Countryside Executive Golf Course  
2506 Countryside Boulevard  
Clearwater, Florida  
HSA Project Number 601-5982-00  
October 19, 2006

Subject: **Countryside Executive Golf Course**  
2506 Countryside Blvd.  
Clearwater, Florida  
*HSA Project Number 601-5982-00*

**Table 3**  
**Summary of Supplemental Analytical Data**  
**Countryside Executive Golf Course, Clearwater, Florida**  
**HSA Project Number 6015982-00**

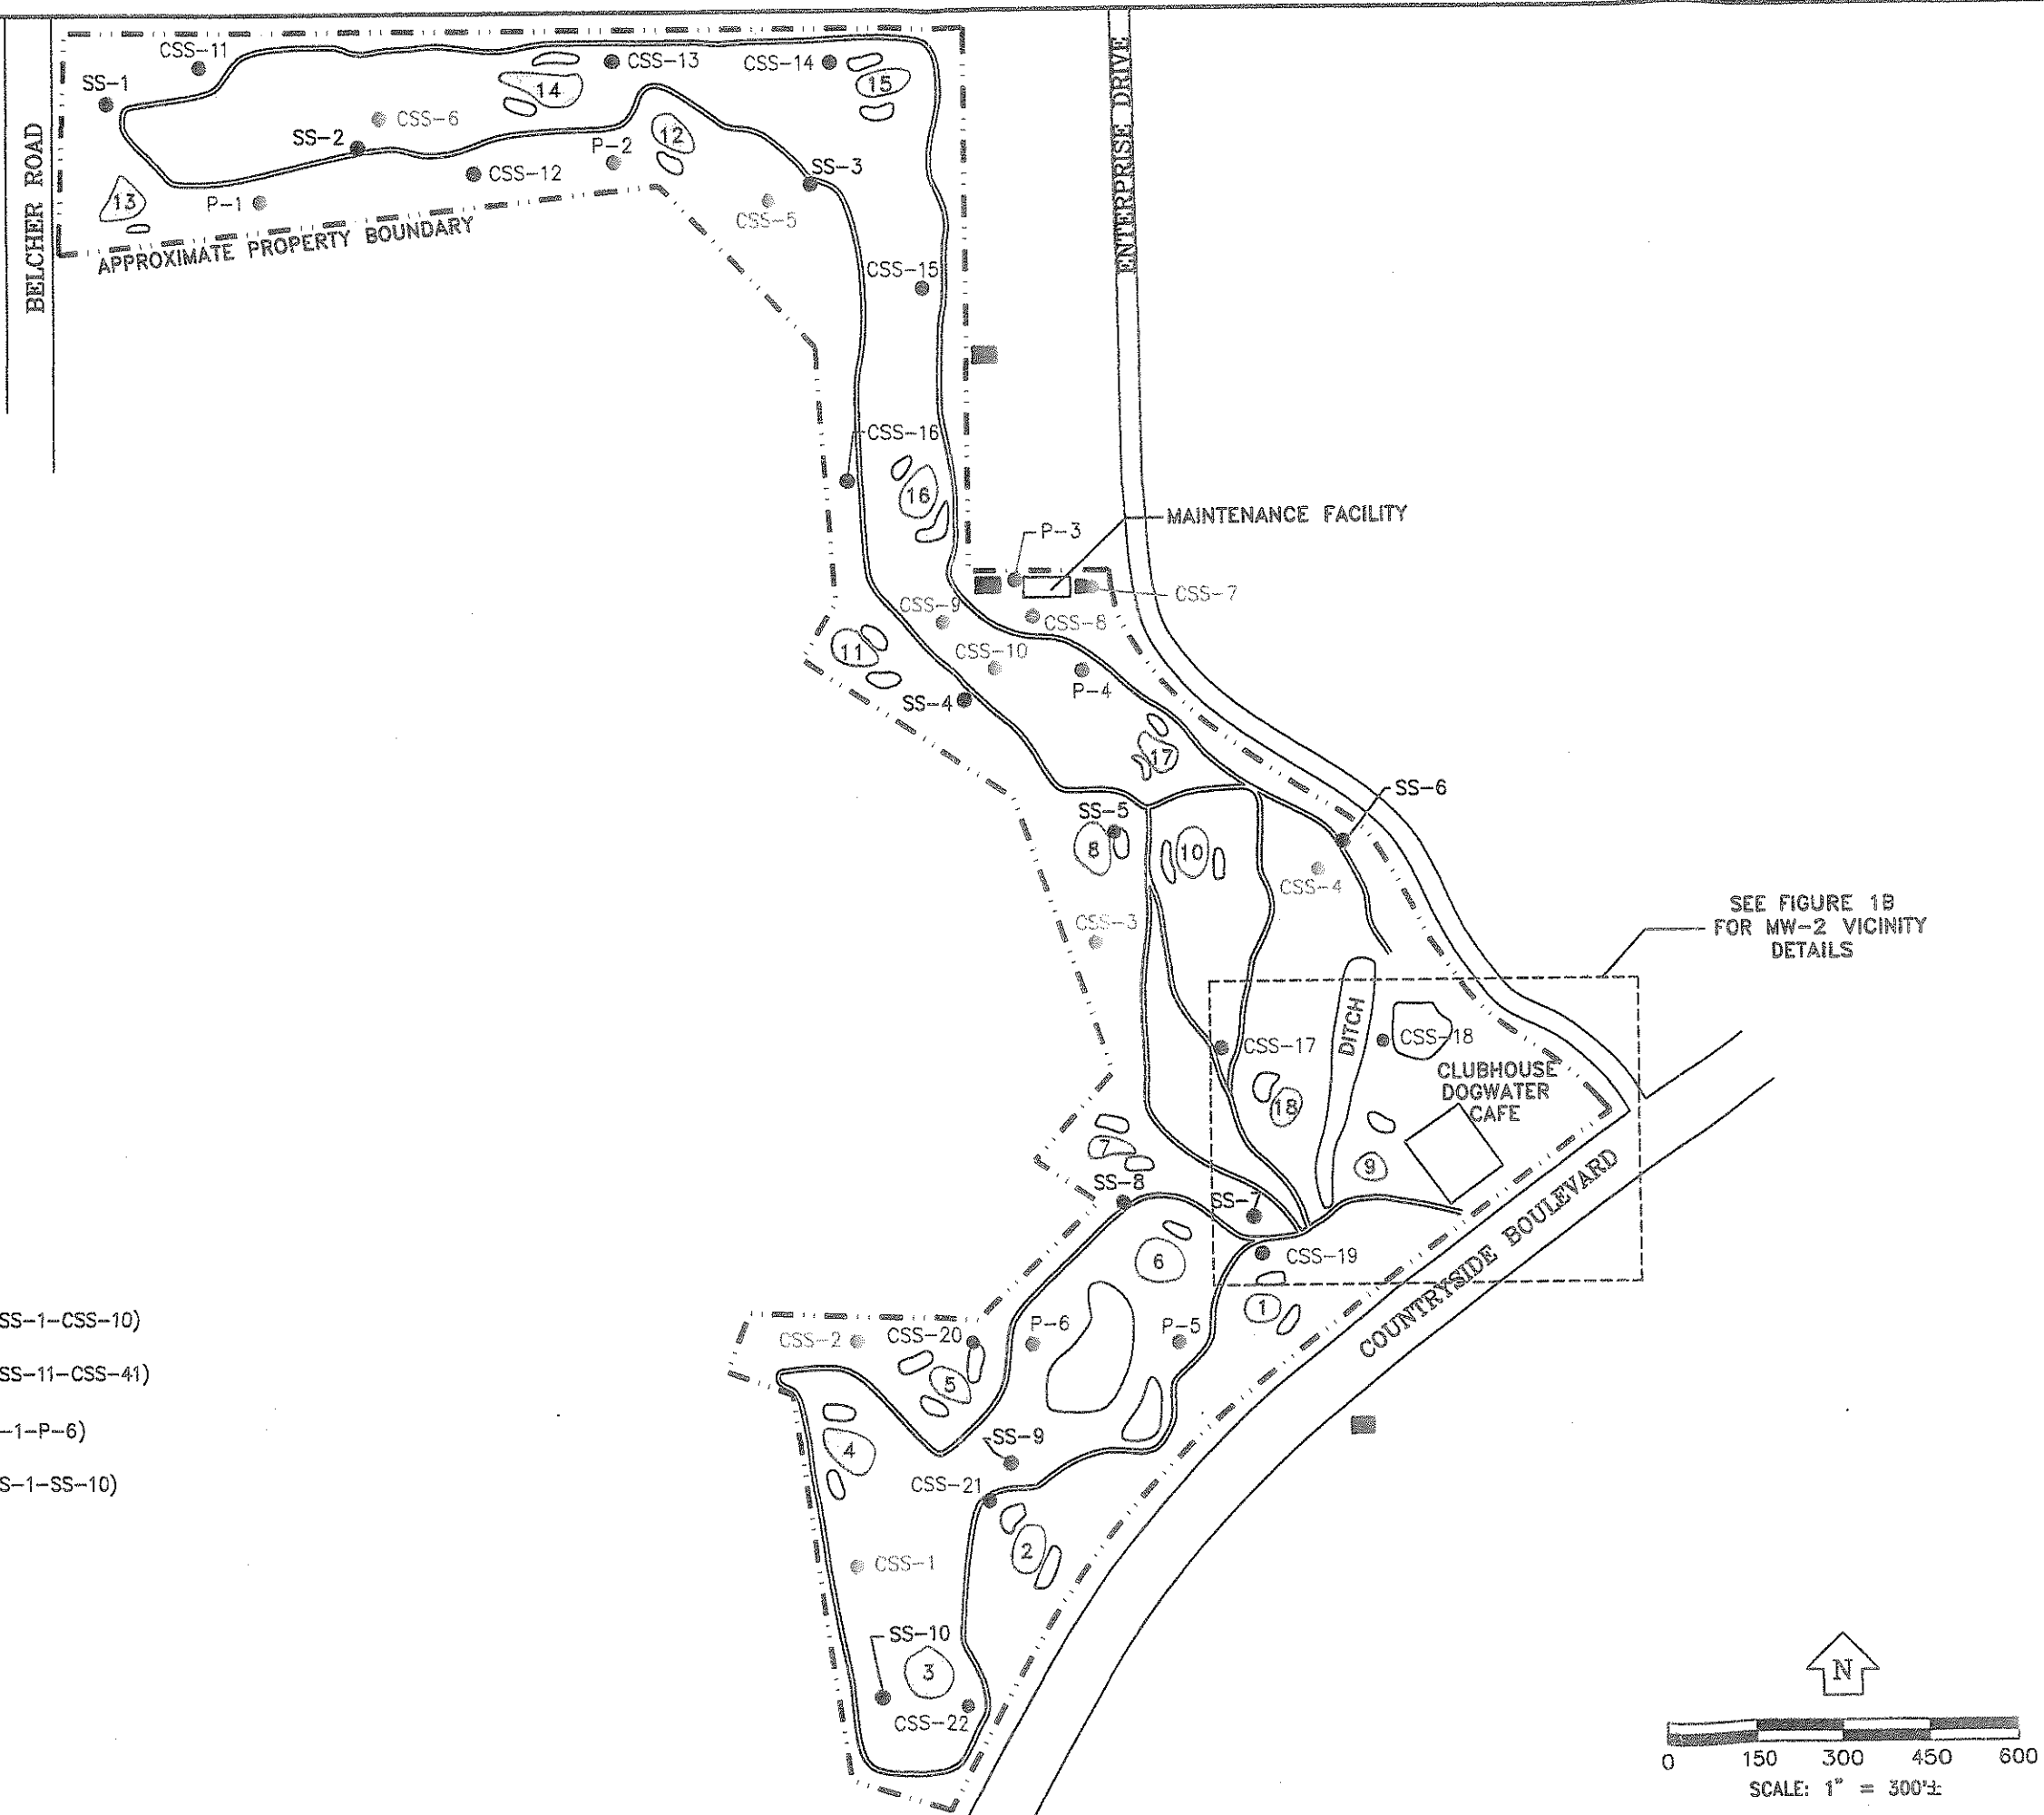
**Comment 6:** *Units for the SCTLs for pesticides and herbicides in Table 3 are incorrect. They should be in mg/kg, not ug/kg.*

**Response:** Acknowledged. The corrected Table 3 is attached.

DESIGNED	N/A	JOB NO.:	601598200
DRAWN	SBW	DATE:	10/3/06
CHECKED	BM	CAD NO.:	598200-1A
SHEET TITLE			
HISTORICAL SOIL SAMPLING LOCATIONS MAP			
FIGURE 1A

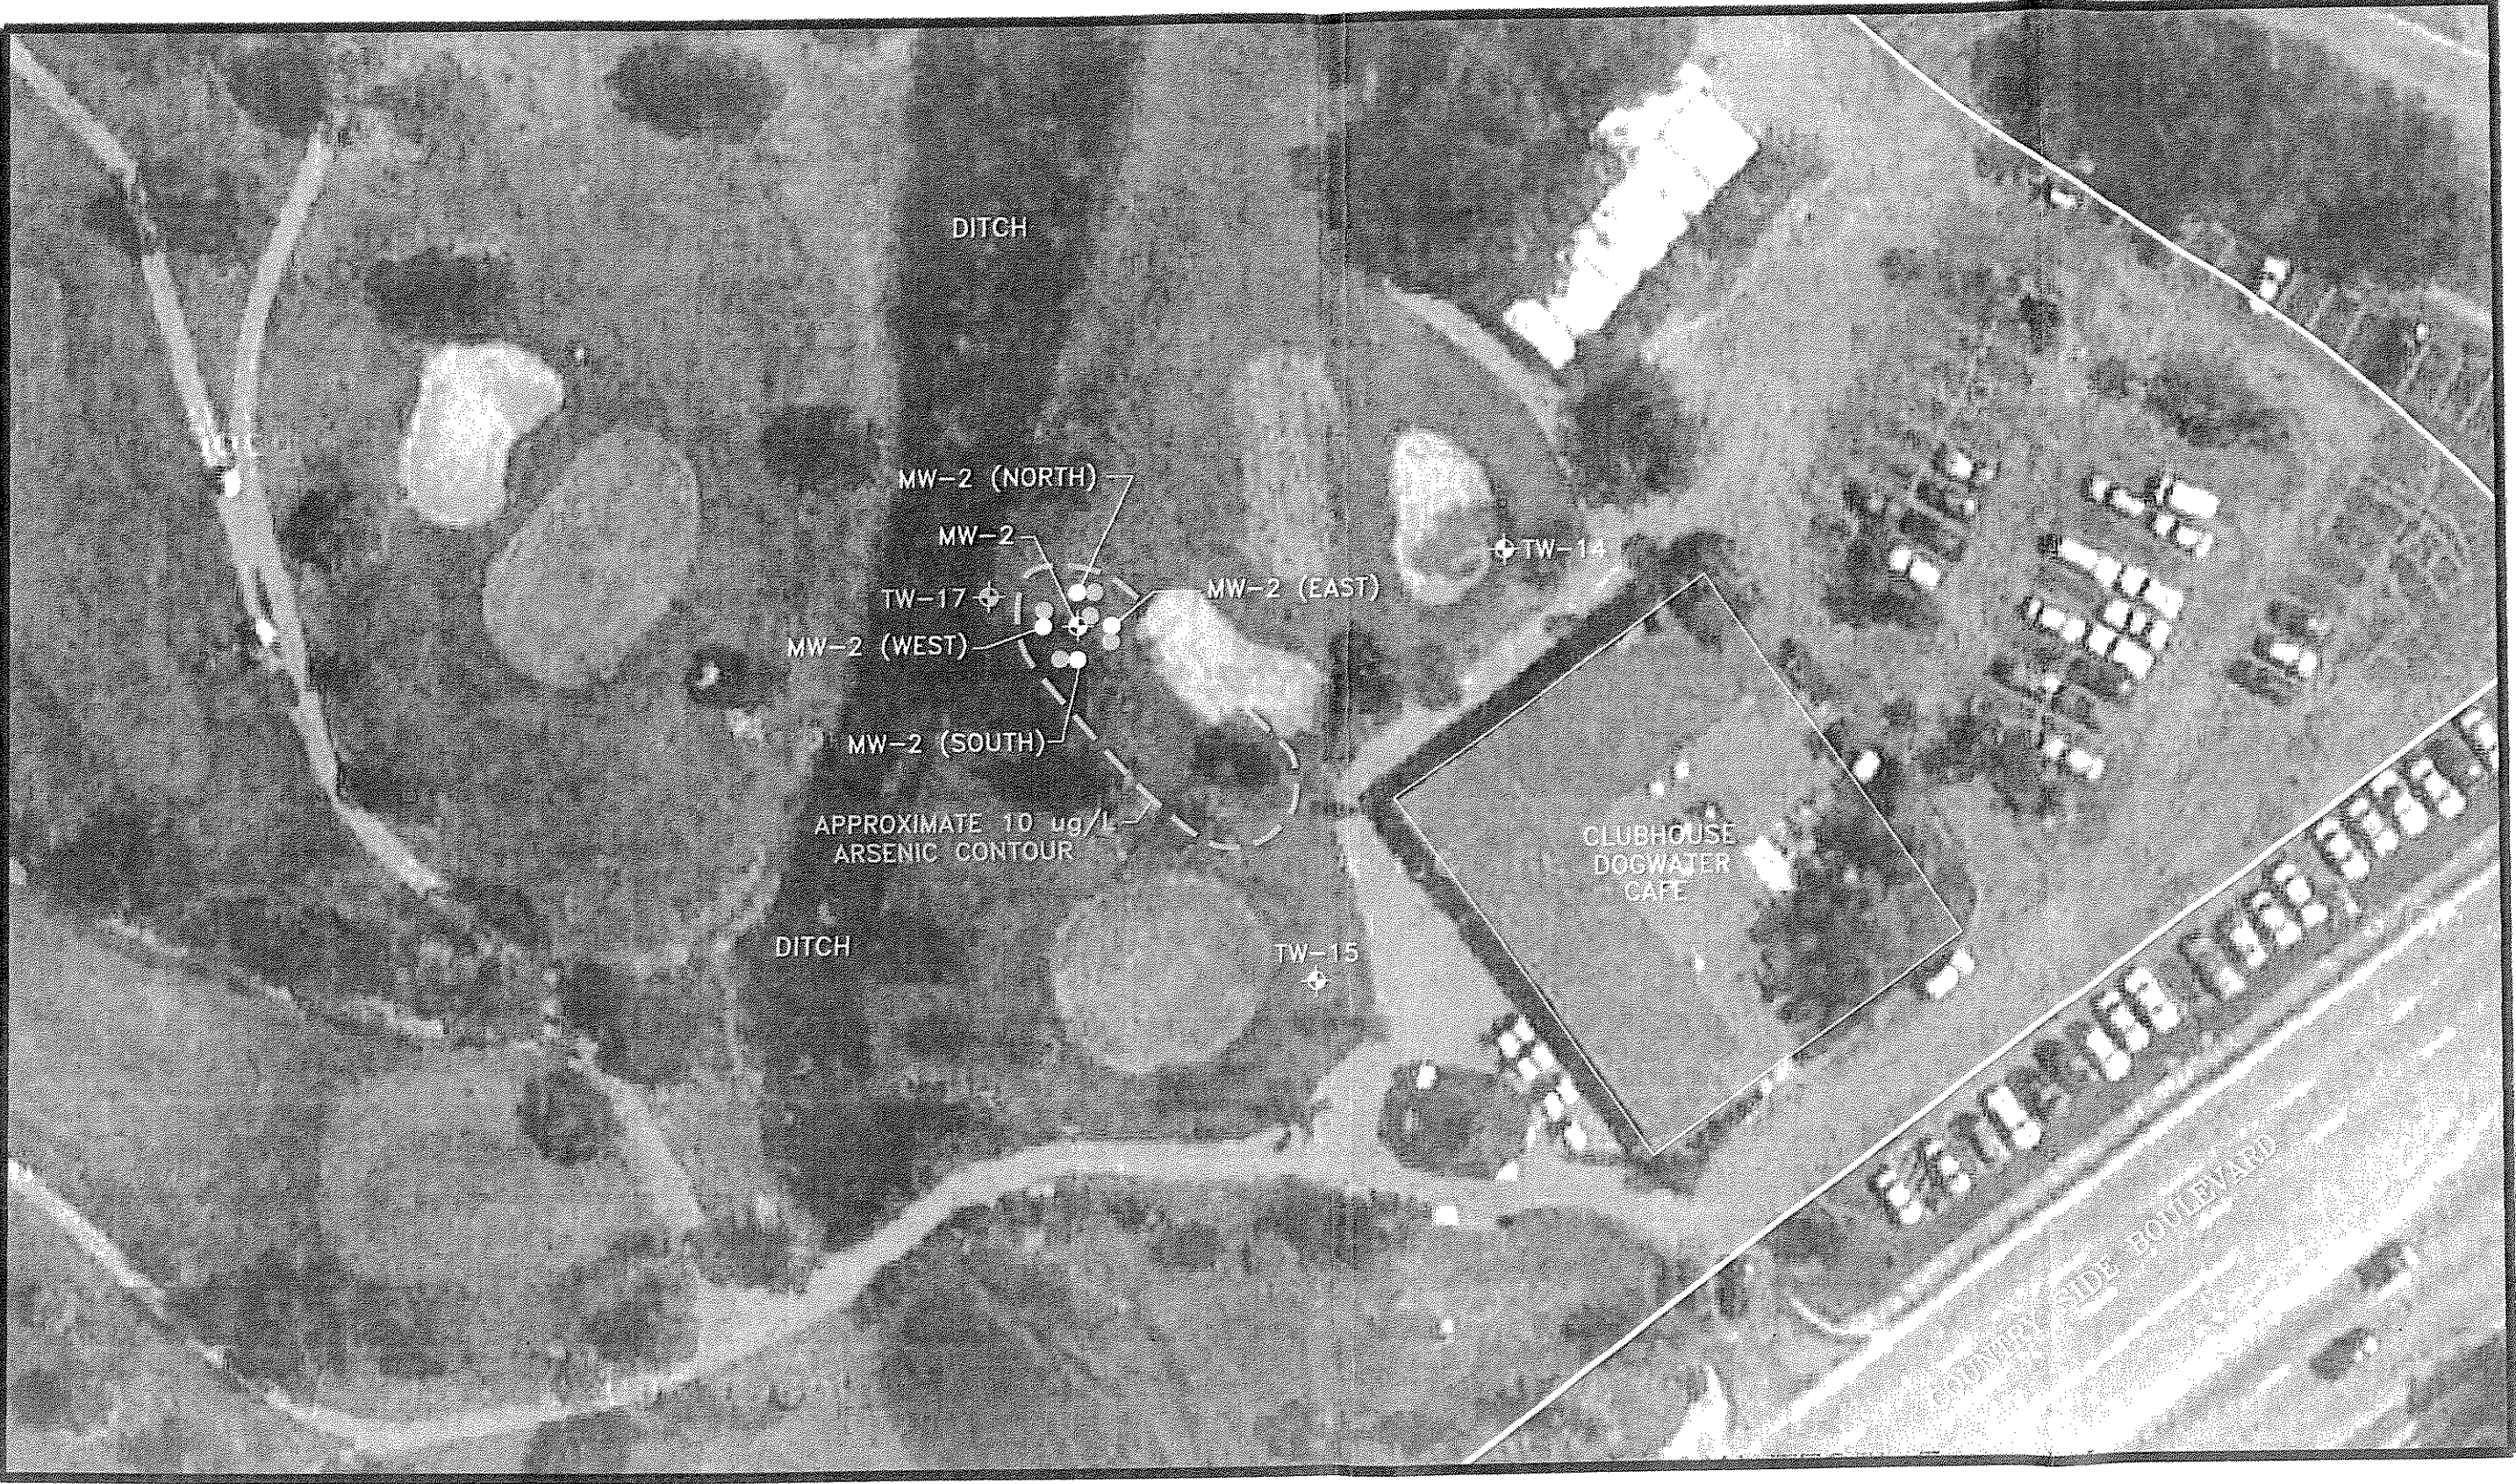
**Comment 1:** *The Report states that the high concentrations of arsenic at MW-2 will attenuate naturally over time. The fluctuations in arsenic concentrations would appear to indicate that natural attenuation is not occurring at this location. Arsenic concentrations increased from 37.3 µg/L to 79.8 µg/L between May 30, 2006 and June 13, 2006.*

In order to further evaluate groundwater quality in the vicinity of monitoring well MW-2, HSA proposes to install one additional groundwater monitoring well (TW-17) to the west of MW-2 as depicted in the attached **Figures 1A and 1B**. The monitoring well will be installed to a total depth of approximately 12 feet below land surface (ft bls) and will be screened from 2 to 12 ft bls. Following installation, TW-17, along with monitoring wells MW-2, TW-14, TW-15, and TW-16 will be sampled and subjected to fixed laboratory analysis for the presence of arsenic.

DESIGNED	N/A	JOB NO.:	601598200
DRAWN	SBW	DATE:	10/12/06
CHECKED	BM	CAD NO.:	598200-02
SHEET TITLE GROUNDWATER ELEVATION MAP (10/12/06)			
FIGURE 2

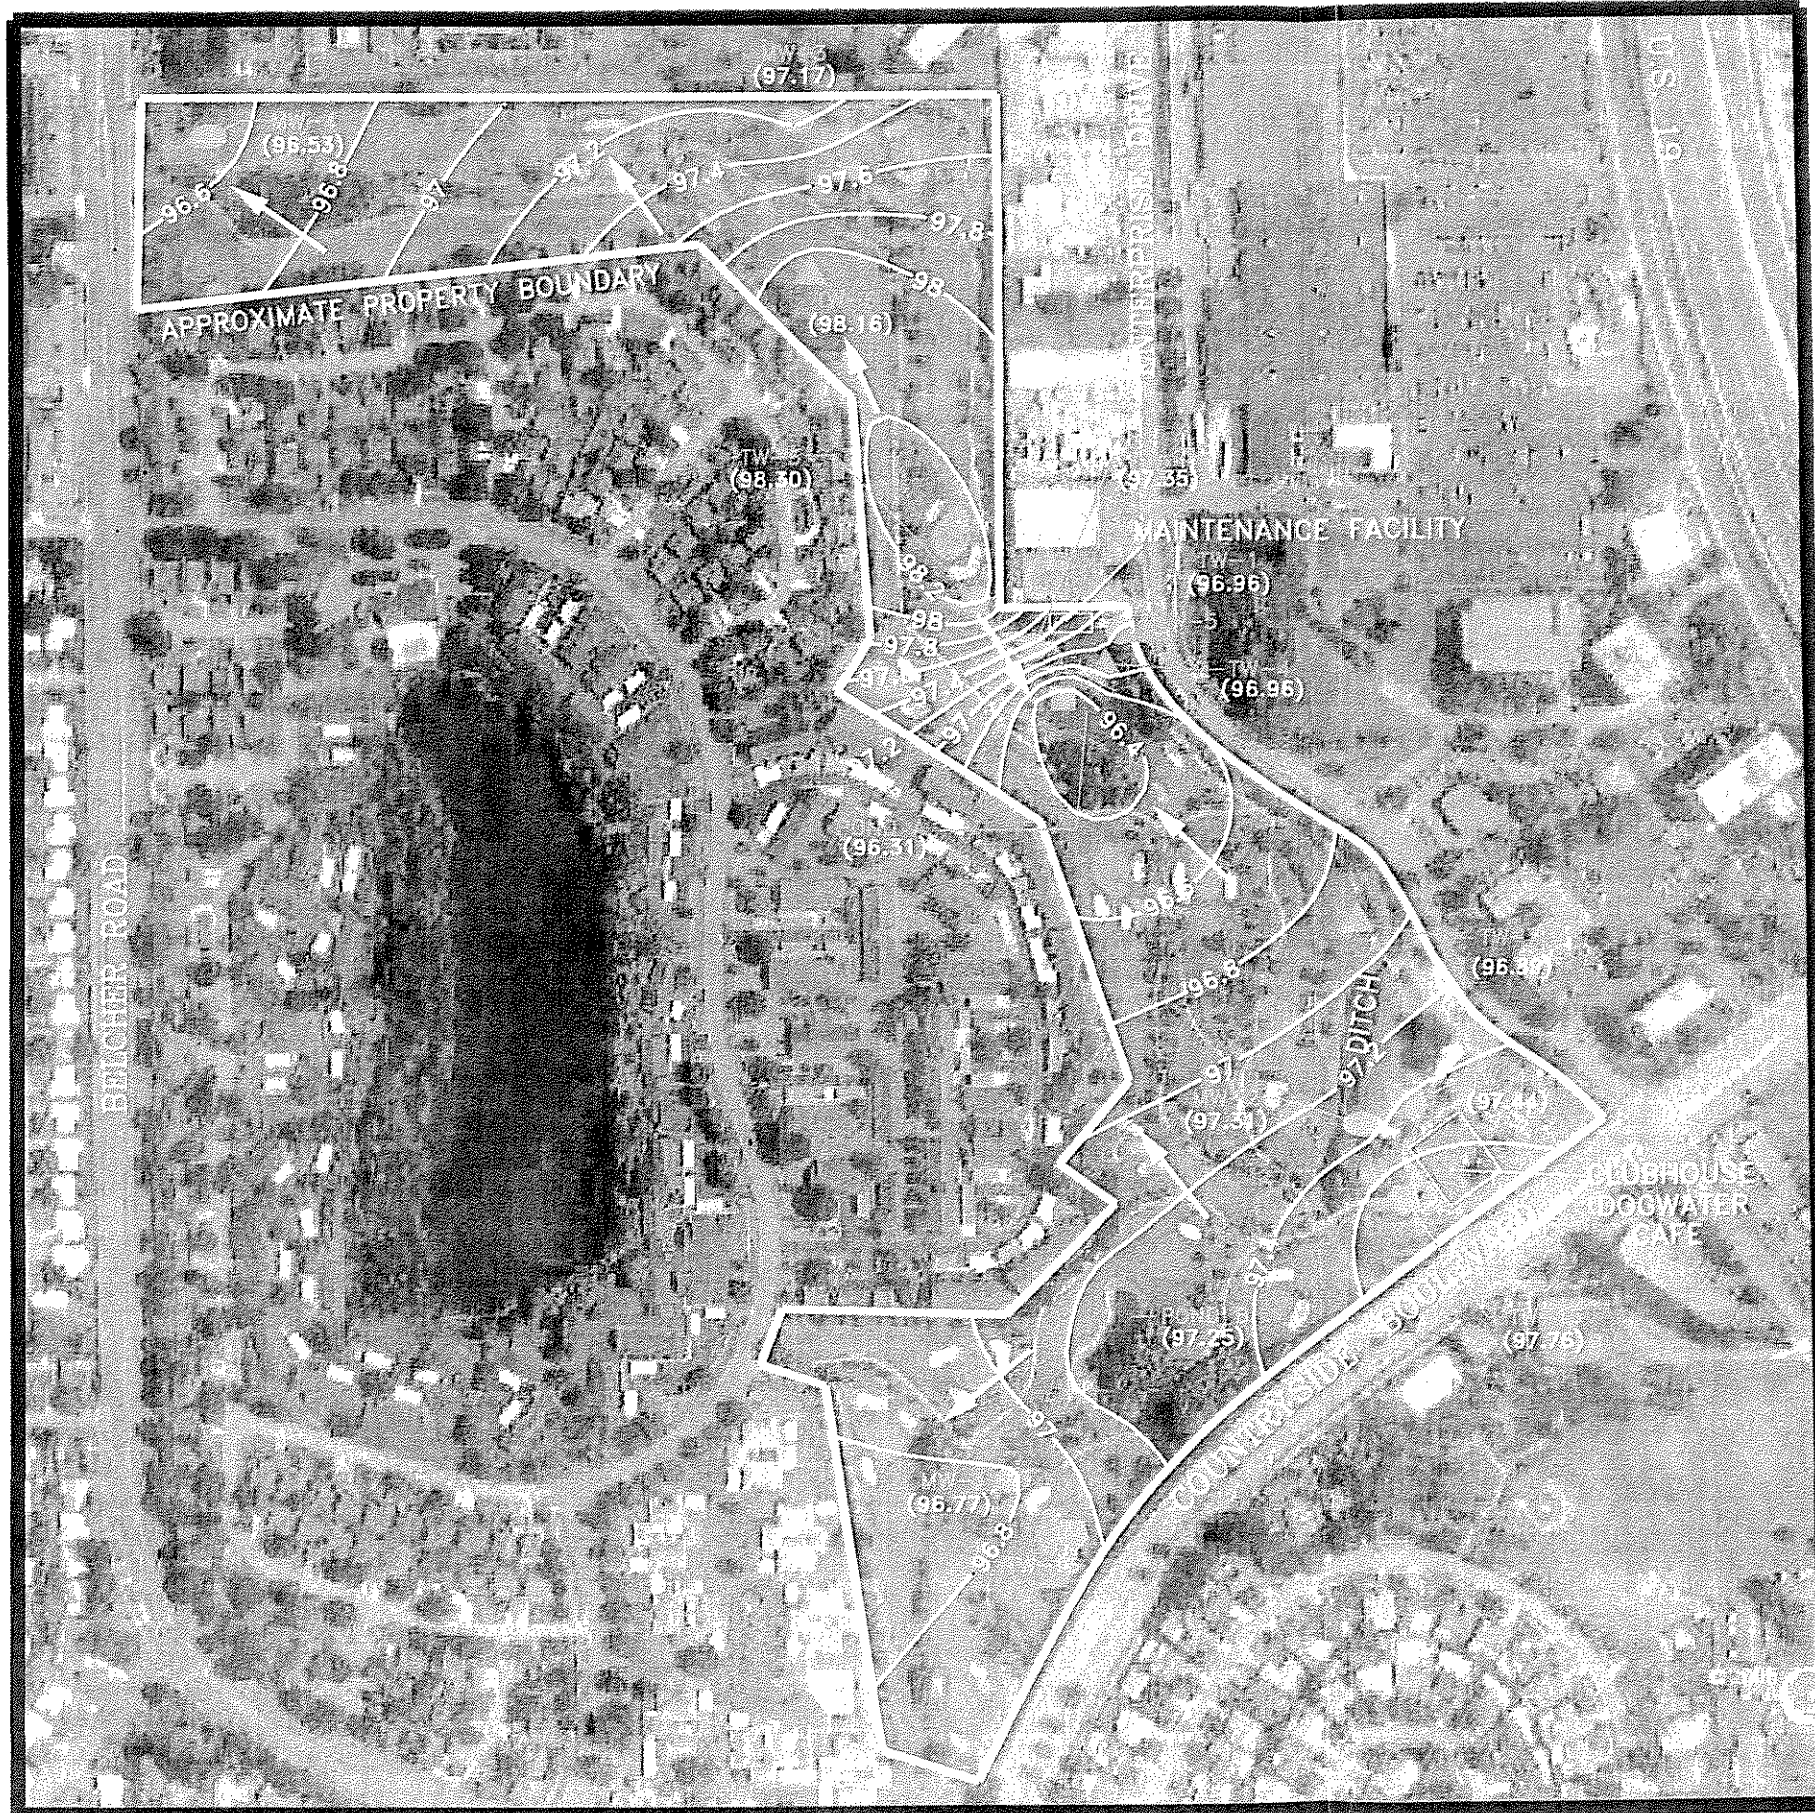
**Comment 7:** *No groundwater flow map for the entire site is presented. This should be included in the next SARA submittal.*

depicting the inferred direction of groundwater flow is included as **Figure 2**. While there remains a predominant southeast direction to regional groundwater flow, locally, the site maintains a significant internal flow component. During the re-sampling of site wells, a second measurement of water table elevation data will be collected to confirm our conclusions as previously offered.

**Response:** Acknowledged. A groundwater flow map for the entire site is included as **Figure 2**. Groundwater elevation data are included in **Table 1**.
